MONTGOMERY COUNTY HISTORIC PRESERVATION COMMISSION
STAFF REPORT

Address:	228 Park Avenue, Takoma Park	Meeting Date:	2/11/2026
Resource:	Contributing Resource Takoma Park Historic District	Report Date:	2/4/2026
Applicant:	Dave & Kris Besch (Richard J. Vitullo, Architect)	Public Notice:	1/28/2026
Review:	HAWP	Tax Credit:	No
Permit No.:	1146781	Staff:	Laura DiPasquale
Proposal:	Fenestration alterations

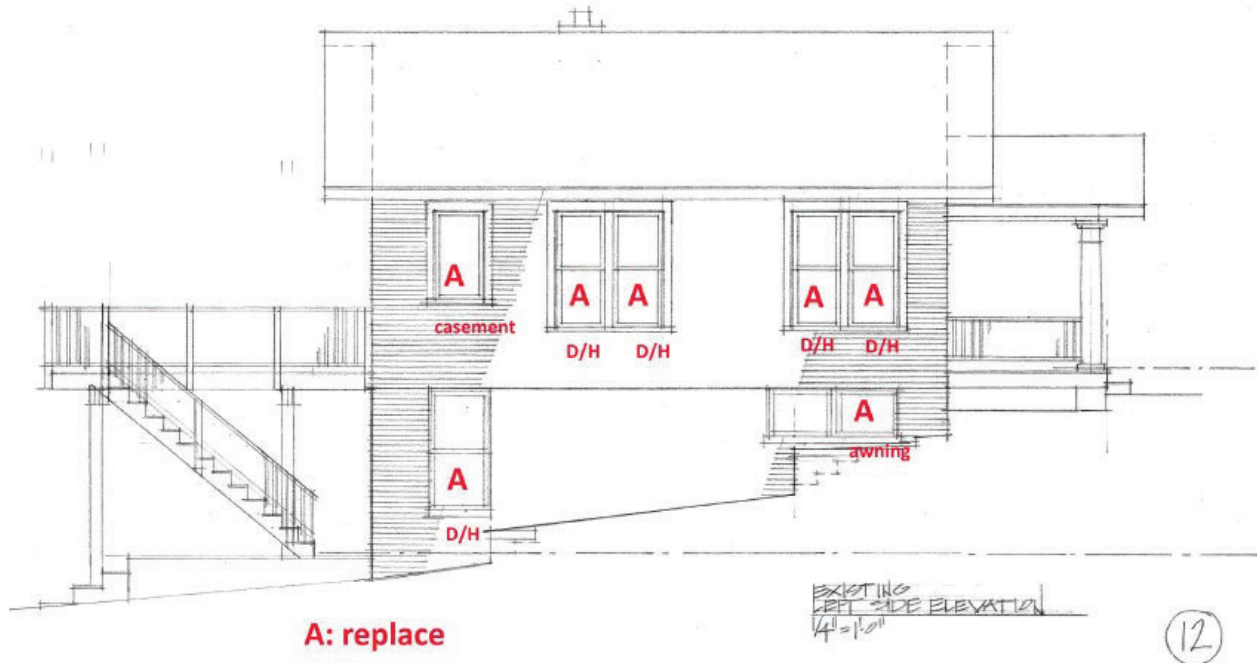
Staff generally supports the proposed project and recommends approval. Staff finds that the existing wood windows have divided lights, while the existing vinyl windows are single-light awning and one-over-one double-hungs. The existing window frames have aluminum capping installed over the original wood frames that are buried beneath non-original exterior faux brick sheathing, as shown in *Figure 8*. Staff has been unable to uncover definitive photographic or documentary evidence of the original window pane configuration that would allow a replication per *Standard 6*, but notes that the *Guidelines* for Contributing resources do not require an exact replication of historic features, instead encouraging the retention of original openings and installation of features that are generally consistent with the architectural style and period of the resource. Based on the style and period of house, design of similar properties in the district, and a grainy photograph of the rear of the subject property, staff finds that the

original double-hung windows were likely divided-light-over-one windows. Staff finds that divided-light-over-one windows would be more compatible than the proposed one-over-one windows, in keeping with *Standard 9* and the *Guidelines*, but does not find that the proposed one-over-one windows are incompatible with the resource. Staff finds that the existing vinyl windows are not original to the building, and therefore their removal does not constitute removal of historic materials, in keeping with *Standards 2* and *9*. Staff finds that the project retains the existing/original size and shape of window openings, per the *Guidelines*. Staff finds that the proposed aluminum-clad Marvin windows are generally compatible in their profiles and dimensions, although there is an additional subframe extension that would not be present on a historic wood window. However, given that the proposed windows do not replace historic wood windows, are to be recessed in the openings, and that the exterior cladding and frame capping is non-original, staff finds that the proposed windows will not substantially alter the exterior features of the resource and are compatible under Chapter 24A-8(b)(1) and (2). Similarly, staff finds that the proposed casement window to replace an existing double-hung will retain the original opening and have limited visibility from the public right-of-way and will not substantially alter the exterior features of the resource, per Chapter 24A-8(b)(1), and the *Guidelines*.

Staff recommends that the Commission **approve** the HAWP application under the Criteria for Issuance in Chapter 24A-8(b)(1) and (2) and (d), having found that the proposal will not substantially alter the exterior features of the historic resource and is compatible in character with the district and the purposes of Chapter 24A;
